### Modified rear hardtop locking element

Vehicle Type: **911 Carrera (996) / 911 Carrera 4 (996)**

Concerns: **Modified rear hardtop locking element.**

Bild...Figure...ill...figura...fig 1

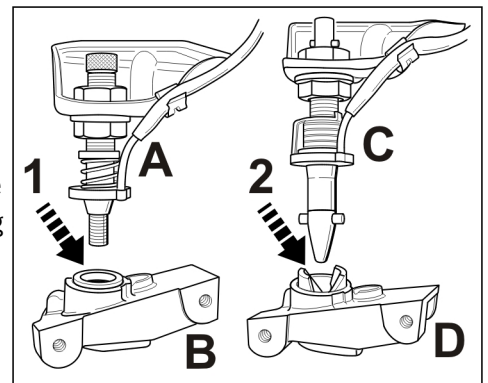
The catch (Figure 1, Item A) and insert of mounting console (Item B) are now threaded (arrow 1) on the modified locking mechanism.

Until now, the hardtop was locked using a bayonet catch (Figure 1, Item C) in the insert of the mounting console (Item D and arrow 2).

The modified locking mechanism can be installed **retroactively** in the event of a repair or complaint. The locking mechanism must be replaced on the left and right (Procedure → Page 2).

It is not permissible to use the previous and the modified locking mechanism (**mixed configuration**) simultaneously.

Bild...Figure...ill...figura...fig 2

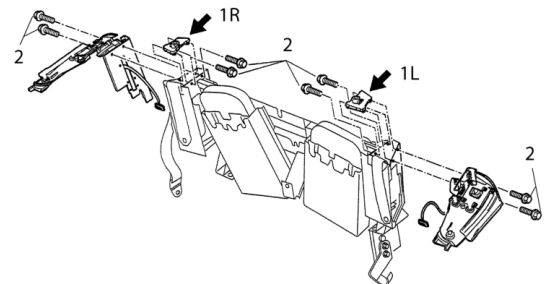
- 3.2 Remove left and right mounting console. The mounting consoles (Figure 2, arrow 1R/1L) are fastened with four M6 x 20 hexagon-head bolts each (Item 2). Disconnect the electric plug connection on the left mounting, → POSES, Workshop Manual 911 Cabriolet, Group 6, 61 42 19 – Removing and installing rear side section flap.

- 3.3 Install modified mounting console on the **left** (996.561.653.04) and **right** (996.561.654.04). Insert mounting console on the left/right on the vehicle and screw down with four M6 x 20 hexagon-head bolts each (Figure 2, Item 2). **Tightening torque: 10 Nm (7.5 ftlb.)**. Join the electric plug connection on the left mounting, → POSES, Workshop Manual 911 Carrera Cabriolet, Group 6, 61 42 19 – Removing and installing rear side section flap.
